Access Compliance Report Public Rights-of-Way (Curb Ramps)

Main Street: ARTISAN_ST Cross Street: BENJAMIN_DR Location: N

ADA ID: RPRK211020163111 Ramp Type: Type 1 - Perpendicular Diagonal Initial Pass/Fail: Pass Overall Compliance: No Severity Score: 20

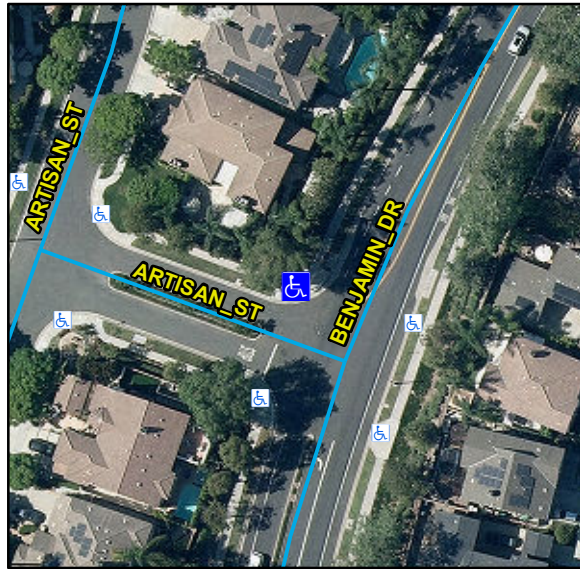
Compliance	Description	Data	Compliance	Description	Data
N/A	Ramp Length (in)	121	N/A	Flare Type LT	
Yes	Ramp Width (in)	48			Sloped
Yes	Ramp Run Slope (%)	7	Yes	Flare Slope LT (%)	3.4
Yes	Ramp Cross Slope (%)	1.3	N/A	Flare Traversable LT	Yes
N/A	Landing Present	Yes	N/A	Flare Type RT	
N/A	Landing Length (in)	38			Sloped
Yes	Landing Width (in)	48	Yes	Flare Slope RT (%)	4.7
No	Landing Run Slope (%)	2.6	N/A	Flare Traversable RT	Yes
Yes	Landing Cross Slope (%)	0.9	No	DWS Provided	No
N/A	Landing Movement Obstructed?	No	N/A	DWS Contrast	N/A
	Landing Movement Type	N/A	N/A	DWS Length (in)	N/A
N/A	Landing Shared	No	N/A	DWS Full Width	N/A
N/A	Clear Space	Yes	N/A	DWS Offset Left (in)	N/A
N/A	Clear Space To Crosswalk (in)	48	N/A	DWS Offset Right (in)	N/A
N/A	Marked Crosswalk 1	No	N/A	Marked Crosswalk 2	No
	Crossing 1 Direction	SW		Crossing 2 Direction	SE
	Marked Crosswalk 1 Width (in)	N/A		Marked Crosswalk 2 Width (in)	N/A

N/A	Ramp Inside Crosswalk 1	N/A	Yes	Ramp Inside Crosswalk 2	N/A
	Crossing 1 Slope (%)	2.9		Crossing 2 Slope (%)	3
	Crossing 1 Cross Slope (%)	0.5		Crossing 2 Cross Slope (%)	2.6
Yes	Gutter Ponding	No	No	Curb Slope	10.9
Yes	Gutter Lip Height (in)	0		Road Run Slope (%)	0.3
No	Gutter Run Slope (%)	5.3		Road Cross Slope (%)	1.4
Yes	Gutter Cross Slope (%)	0.5			
Yes	Overall Surface Condition: Acceptable		No	Perp Joint Present	No
	Cross Gutter Present?	No		Spandrel Present?	No
	Replace Cross Gutter?	N/A		Replace Spandrel?	N/A

Remove & Replace Curb Ramp With Two New Directional Ramps or Equivalent. Remove & Replace Gutter.
